BUILDING PERMIT REPORT

ADDRESS: 76 BUCA RUN 336-H-052

WORK FOR PERMIT: To Construct 6'x24' Porch - 14'x24' garage on Ex. Foundation.

LAND USE - ZONING REPORT

LOT 2 BUCA RUN

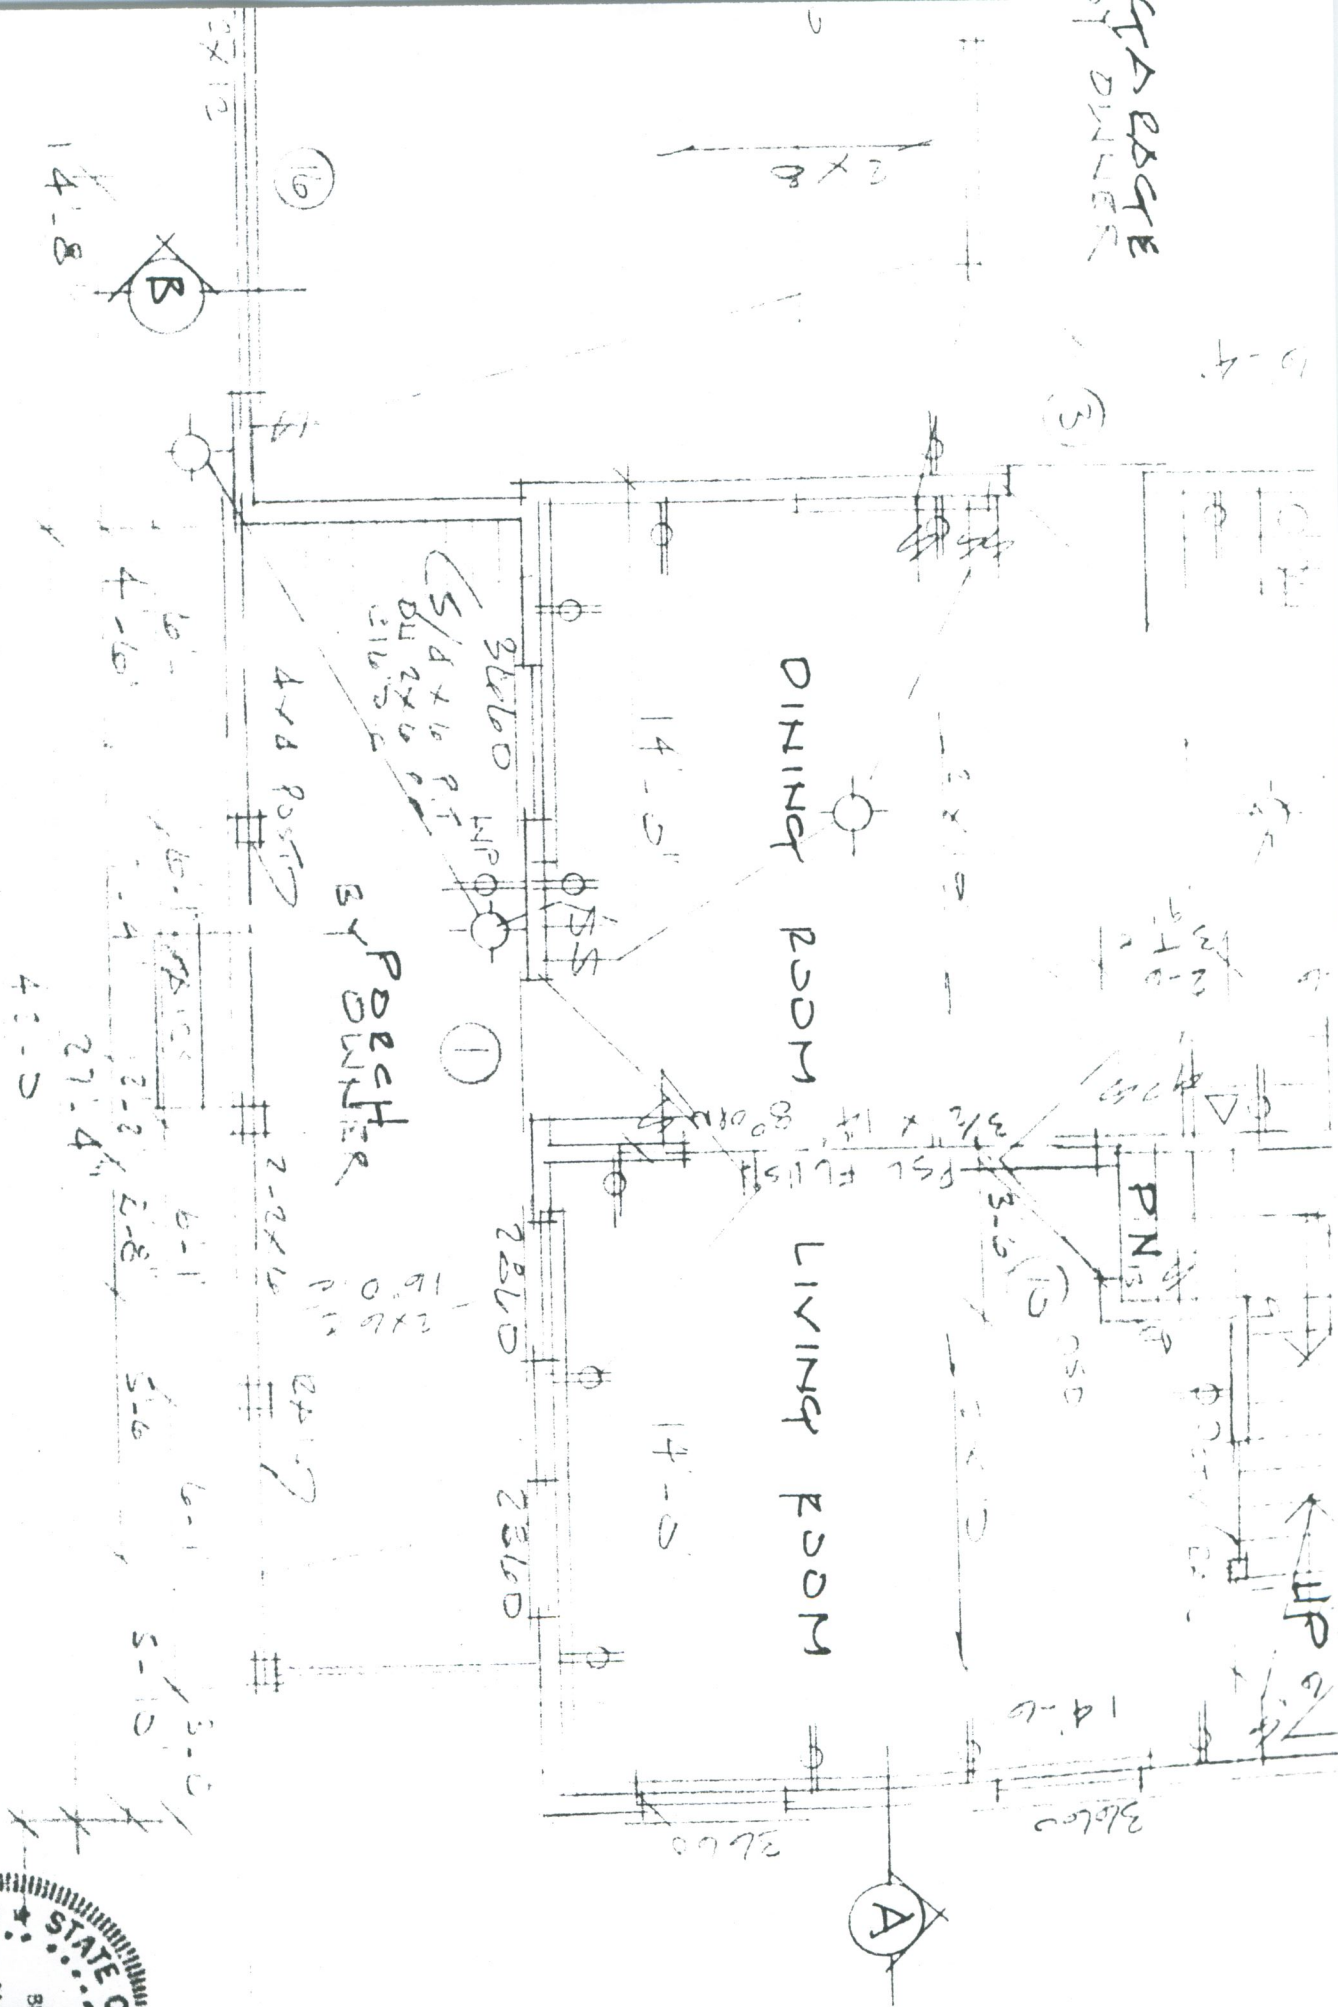
SETBACKS: FRONT + REAR - 25'
SIDES - 12'

Lowest bldg opening
74.2

sill el.
75.7

Front Yard - 25' req - 25' shown

Rear Yard - 25' req - 25' + shown

Side Yard - 12' req - 17' shown
